Title: Advisory Committee on Reactor Safeguards
547th Meeting

Date: Friday, November 2, 2007

SELECTED CHAPTERS OF THE SER ASSOCIATED WITH

ESBWR DESIGN CERTIFICATION 5

Overview of Chapter 5 – Reactor Vessel

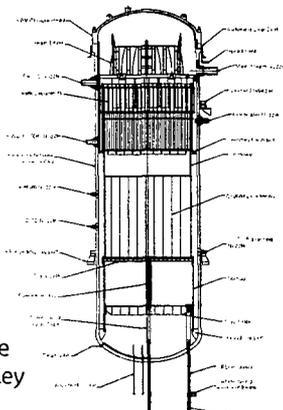
24 MEMBER ARMIJO: So is the nozzle forging
25 shaped to provide that -

7 MEMBER ARMIJO: Right. It's the tolerance
8 of an antiquated fabrication technique that is so
9 detrimental to the performance of materials in the
10 BWR, in particular. Let me ask a couple of questions.
11 GE, have you reviewed the incidents of IGSEC on 316
12 nuclear grade shrouds in Japan? Are you familiar with
13 that event?

1 recommend that GEH take a -- do another review of the
2 materials control and the water chemistry to avoid
3 future stress corrosion cracking problems in this
4 plant. And I think the staff should put some pressure
5 on you to do that. With that said, I'll be quiet.

11 MEMBER ARMIJO: I've spent too many years
12 of my life finding and fixing stress corrosion cracks
13 in the BWRs. And when I see this type of stuff, I can
14 see it coming down -- I see a train wreck coming on a
15 new plant where it's totally unnecessary if you apply
16 the lessons learned from BWR operation.

Overview of Chapter 5 – Isolation Condenser System

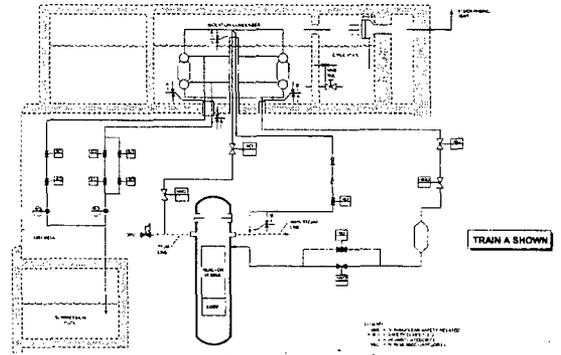
6 MEMBER ABDEL-KHALIK: I think the question
7 was brought up at the Subcommittee meeting, as to the
8 effect of loss of nitrogen on the operation of the
9 iso-condenser system, where that nitrogen operated
10 isolation valve would actually fail open. And whether
11 the sudden sort of entry of a large volume of cold
12 water into the vessel during operation. I guess that
13 particular transient has been analyzed and shown to be
14 non-limiting?
